BELL BEND NUCLEAR POWER PLANT
RESPONSE TO ENVIRONMENTAL
REQUESTS FOR ADDITIONAL
INFORMATION, SEVENTH
SUBMITTAL
BNP-2009-342 Docket No. 52-039

Responses to Environmental Requests for Additional Information
Bell Bend Nuclear Power Plant
Luzerne County Pennsylvania

Revised Figure 2.3-34 {Wilkes-Barre/Scranton, Pennsylvania, Wind Rose}

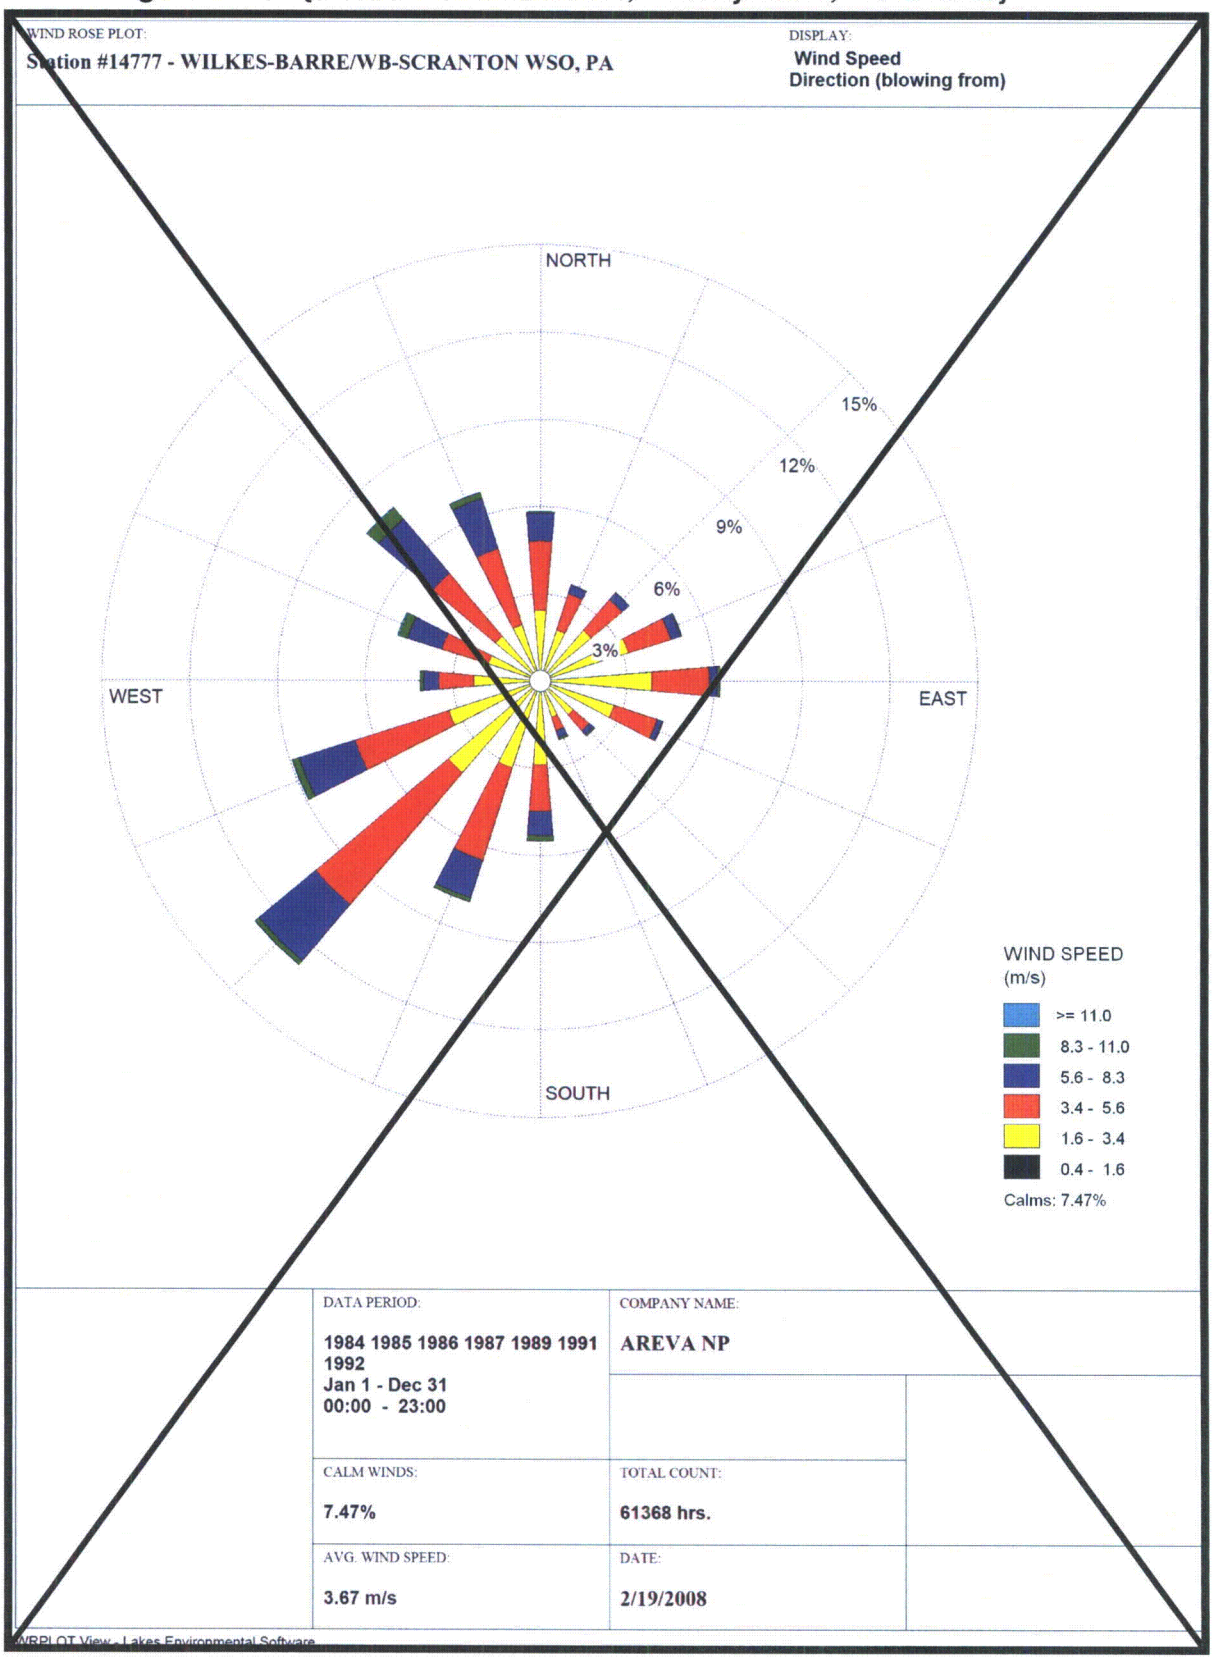
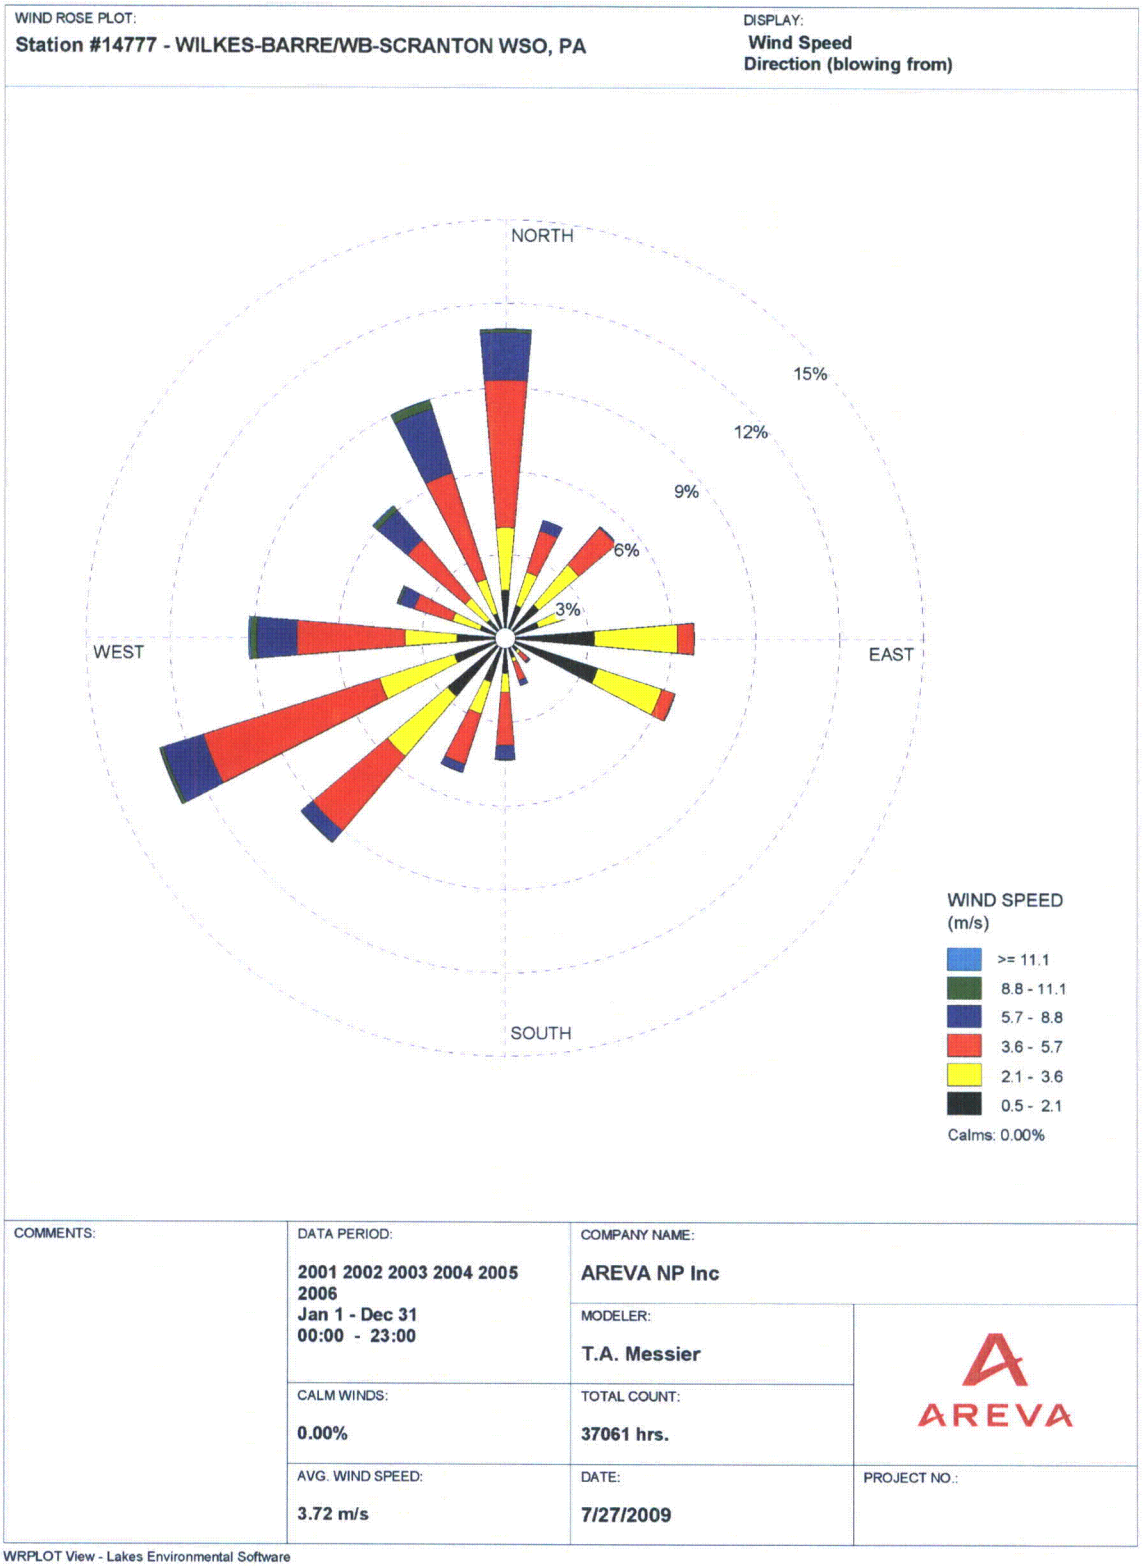
COLA Impact:
BBNPP COLA FSAR Sections 2.3.2.1.1 will be revised, and FSAR figures 2.3-34, 2.3-35, and 2.3-36 will be revised, as follows, in a future revision of the COLA:

Figure 2.3-34 through Figure 2.3-36 present multi-year average annual wind rose plots for National Weather Service (NWS) stations around BBNPP (Wilkes-Barre/Scranton, Allentown, and Williamsport, Pennsylvania). Meteorological data used to create the plots were received from the U.S. National Climatic Data Center ~~Environmental Protection Agency Support Center for Regulatory Air Models~~ and were measured at approximately 33 ft (10 m) above ground level. ~~For Wilkes-Barre/Scranton, the meteorological data were from 1984 through 1987, 1989, 1991 and 1992.~~ For all three stations ~~Allentown and Williamsport~~, the meteorological data were from 2001 through 2006 ~~1984 through 1992~~.

The annual prevailing wind direction at Wilkes-Barre/Scranton, Pennsylvania, is from the southwest, approximately 13% of the time (Figure 2.3-34). At Allentown, Pennsylvania, the annual prevailing wind direction is from the west-southwest, approximately 13.5% ~~10%~~ of the time (Figure 2.3-35). At Williamsport, Pennsylvania, the annual prevailing wind direction is from the west, approximately 24% ~~12%~~ of the time (Figure 2.3-36).

The average wind speed at Wilkes-Barre/Scranton, Pennsylvania, is 3.72 mps (8.3 mph) ~~3.67 mps (8.2 mph)~~ and there have been observations of wind speeds up to 11 mps (25 mph) (Figure 2.3-34). At Allentown, Pennsylvania, the average wind speed is 3.79 mps (8.5 mph) ~~3.92 (8.8 mph)~~ and there have been observations of wind speeds greater than 11 mps (25 mph) (Figure 2.3-35). At Williamsport, Pennsylvania, the average wind speed is 3.87 mps (8.7 mph) ~~3.44 (7.7 mph)~~ and there have been observations of wind speeds greater than 11 mps (25 mph) (Figure 2.3-36). Note that the most prevalent wind speed class on an annual basis for the 10-meter (33-feet) level at SSES (0.5-1.0 mps (1.1-2.2 mph)) is lower than the average annual wind speeds at the same measurement height for these three NWS stations; this would lead to more conservative atmospheric dispersion estimates using the SSES onsite meteorological data.

Revised Figure 2.7-55 SSES 10m Annual Wind Rose

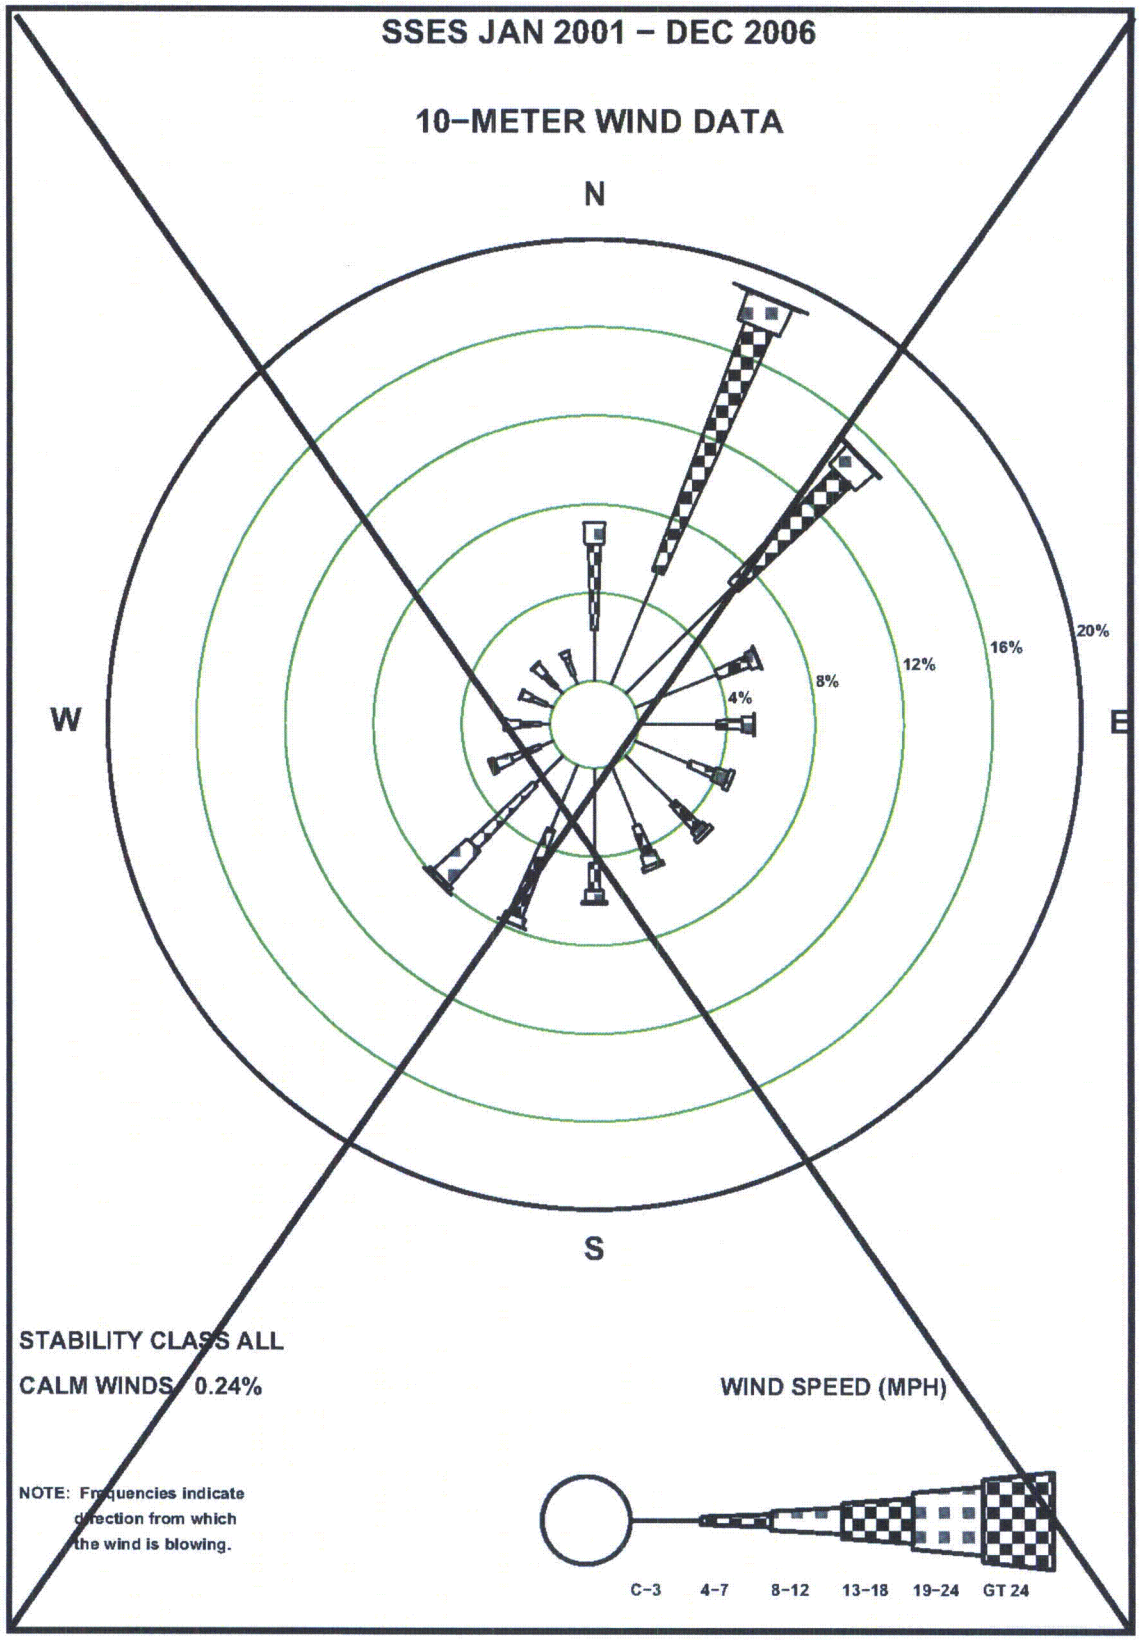
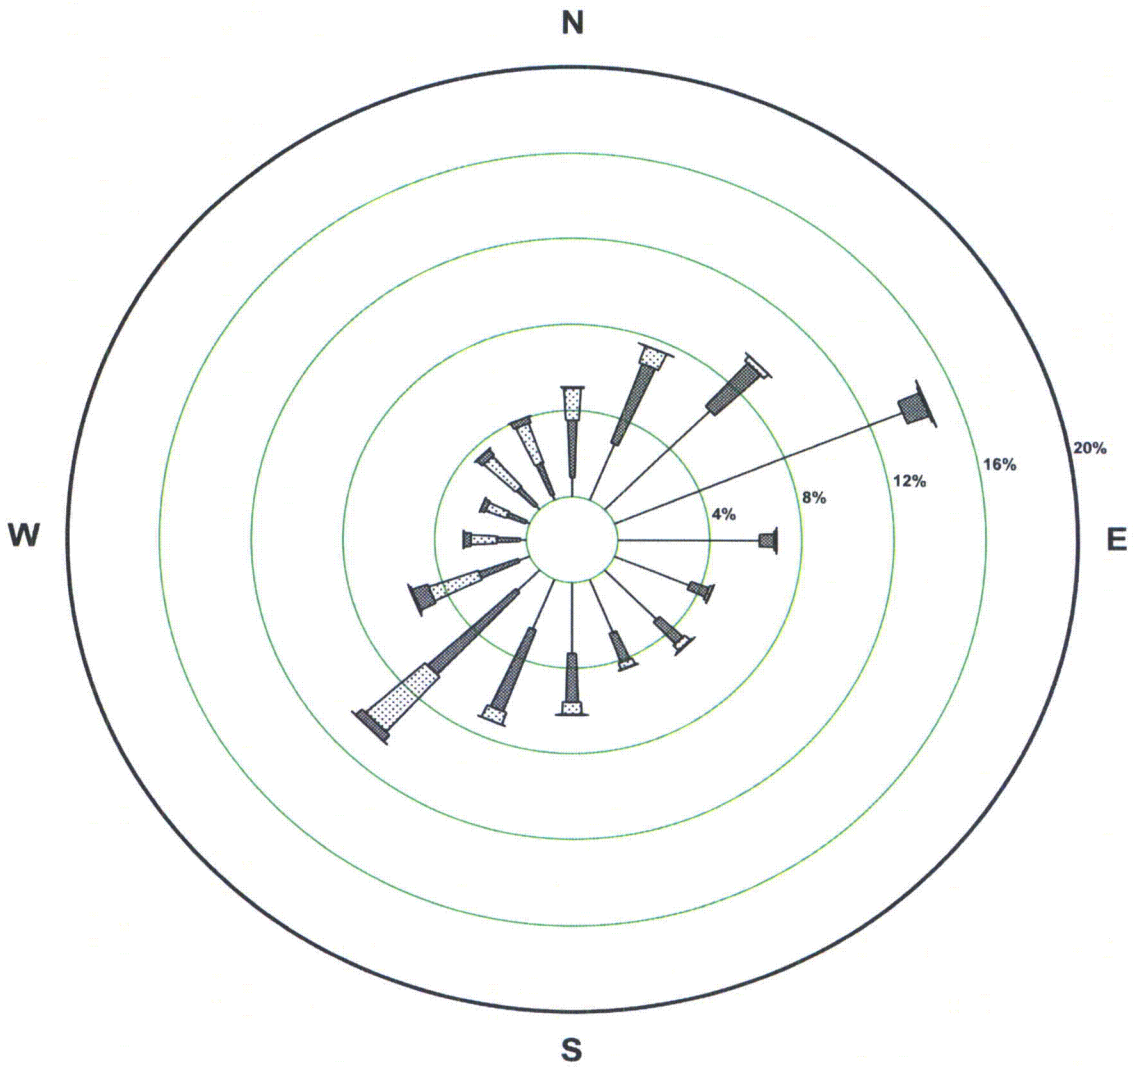
Summary: *Provide the period of record for the data used to construct the windrose plots in the ER for Figures 2.7-89, 2.7-90, and Figures 2.7-91. Provide a comparison of the NWS windrose plots to the annual 10- and 60-meter windrose plots for SSES in Figures 2.7-55 and 2.7-72, respectively. Provide an explanation for the increased frequency of winds from the NNE and NE at SSES when compared to the NWS stations.*

Revised figures constructed using the same period of record as was used for the SSES wind rose plots (2001-2006) are presented below. For comparative purposes, a revised 10 meter wind rose for SSES, ER Figure 2.7-55, is presented below. The 60 meter wind rose is not used in the comparison since the NWS towers do not take measurements at that height.

Figure 2.7-55 through Figure 2.7-88 depict annual, seasonal, and monthly wind rose plots made using six years of SSES onsite meteorological data (2001-2006) for the 33 ft (10 m) and 197 ft (60 m) elevations.

A comparison of Figure 2.7-55 with Figures 2.7-89, 2.7-90, and 2.7-91 indicates that there are more than twice as many low-wind speed events measured at SSES than at the three NWS sites. This lends credence to the idea that differences in wind speed group frequencies between the BBNPP site and the three NWS sites may be attributable to the differing goals of the meteorological measurement programs – atmospheric dispersion (low-wind speed events more important) versus general aviation (high-wind speed events more important).

Figure 1 - BBNPP Discharge Plan View Dimensions Sketch

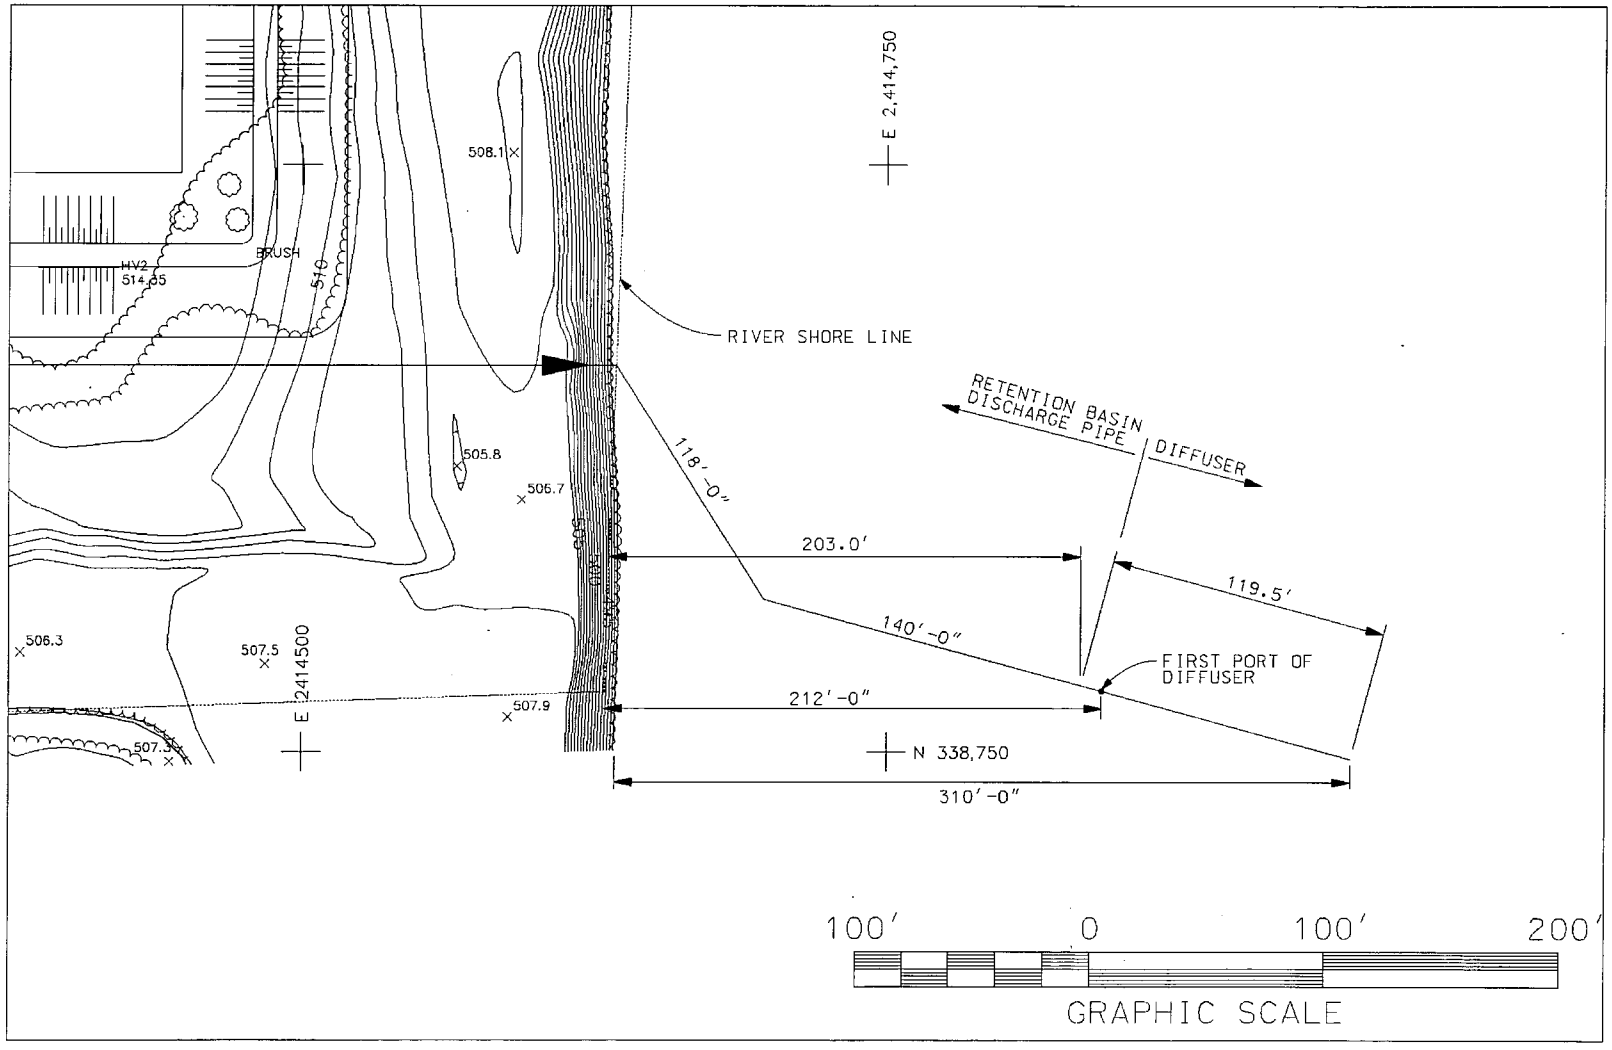
Full Text: There are various discussions in the ER text that indicate different lengths for the discharge pipe. The text (Ch. 3) describes the cooling system discharge pipe as extending 212 ft from shore with a diffuser that is 106.5 ft long from first port to last with 72 4-in.-diameter ports spaced at 1.5-ft intervals. The text in ER Ch. 5 describes a 120-ft-long diffuser, which would give a total pipe length of 332 ft. The text on ER Rev 1, p. 5-22 describes a 200 ft pipe. Figure 3.4-6 appears to show the diffuser as being only 40.5 ft from first port to last with 28 4-in.-diameter ports spaced at 1.5-ft intervals. Note also that text in aquatic ecology impacts seems to differ (ER Rev 1, p.4-45) but is close to dimensions in ER Chapter 5.

Response: See Figure 1 below for a BBNPP discharge plan-view dimensions sketch.

The discharge pipe is buried until it reaches the proximity of the diffuser.
